CUT PATTERN	
BACK FRAME NO.	
BASE FRAME NO.	
WOOD PATTERN

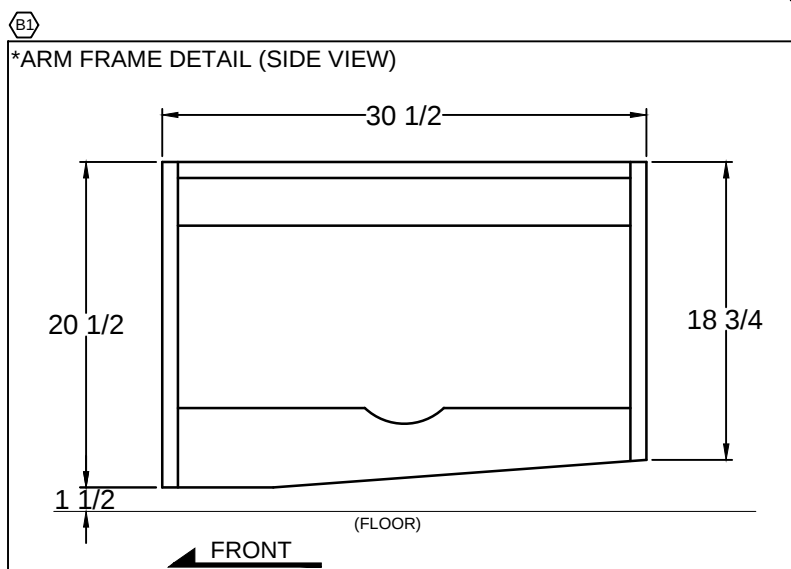
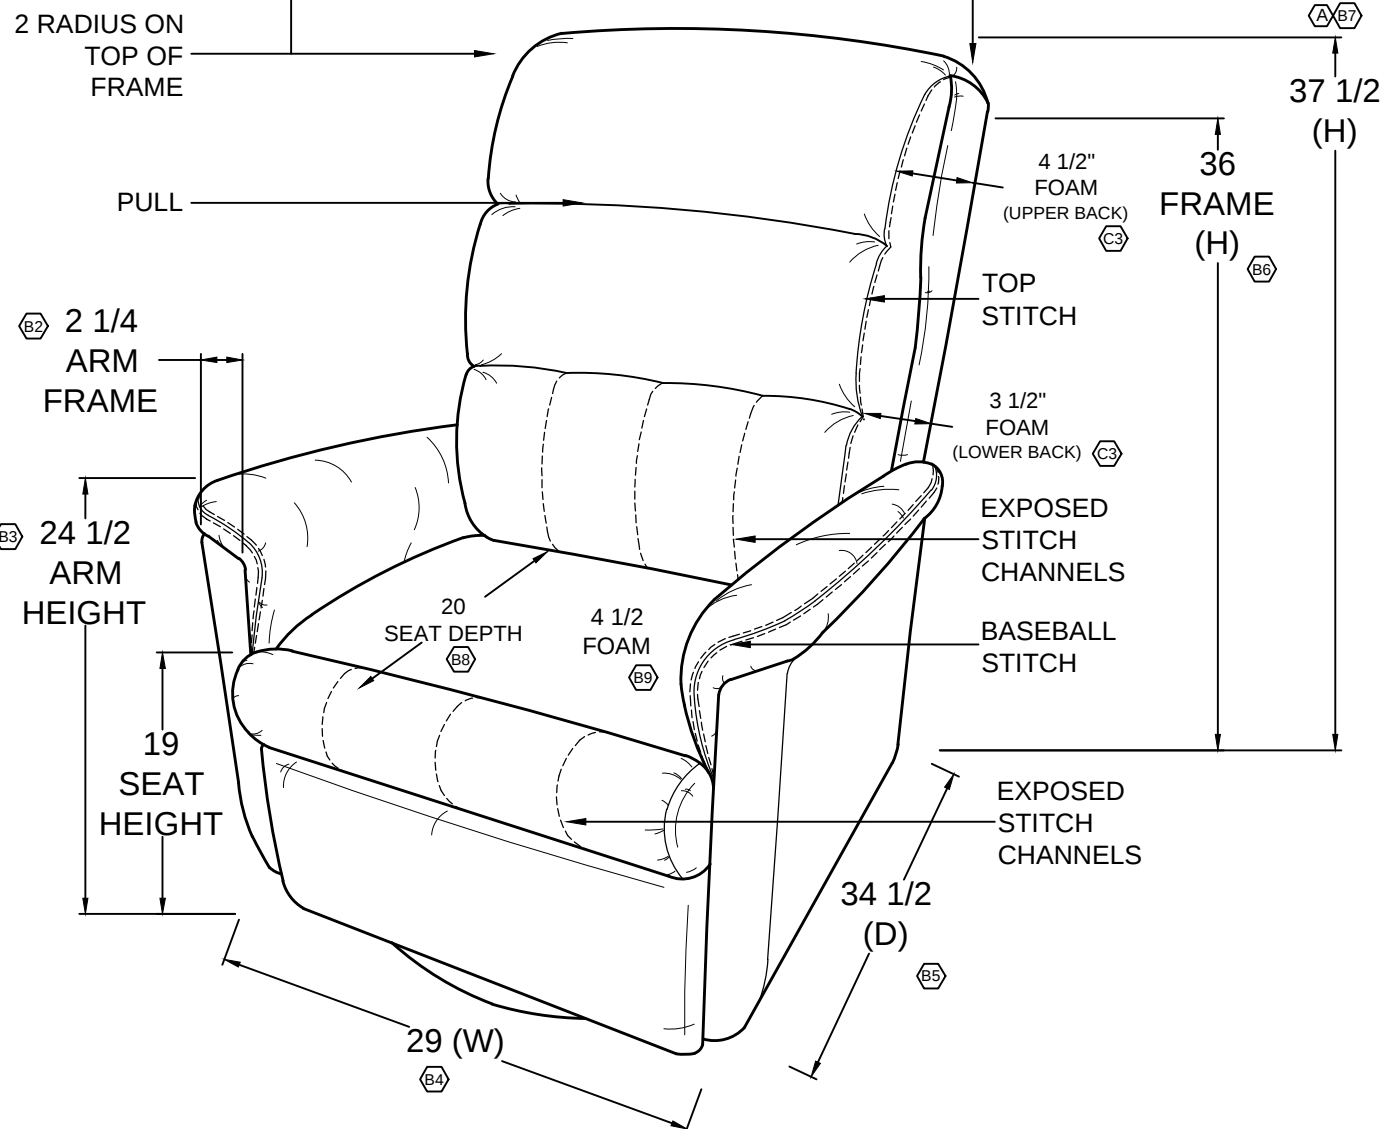
JA	C	[1] ADD SPRING CLIPS TO SEAT SPRINGS. [2] ADD 8x24 802 SPRINGS x4. [3] ADD 4-1/2" FOAM TO UPPER BACK & 3-1/2" FOAM TO LOWER BACK. (REF. ECO #029-2019). [4] MECHANISM LEG A410812333S 23" WIDE MECH W/ SWIVEL 4108-2. (REF. ECO #036-2019)	06.10.19
JA	B	PRODUCTION UPDATE: [1] ADD ARM FRAME DETAIL. [2] CHANGE ARM FRAME WIDTH TO 2-1/4"; WAS 2". [3] CHANGE ARM HEIGHT TO 24-1/2"; WAS 27". [4] CHANGE WIDTH TO 29"; WAS 28-1/2". [5] CHANGE DEPTH TO 34-1/2"; WAS 36-1/2". [6] CHANGE FRAME HEIGHT TO 36"; WAS 35-1/2". [7] CHANGE O.A. HEIGHT TO 37-1/2"; WAS 38". [8] ADD 20" SEAT DEPTH. [9] ADD 4-1/2" SEAT FOAM	01.28.19
JA	A	PER RL, O.A. HEIGHT IS 38"; WAS 40-1/2".	11.08.18
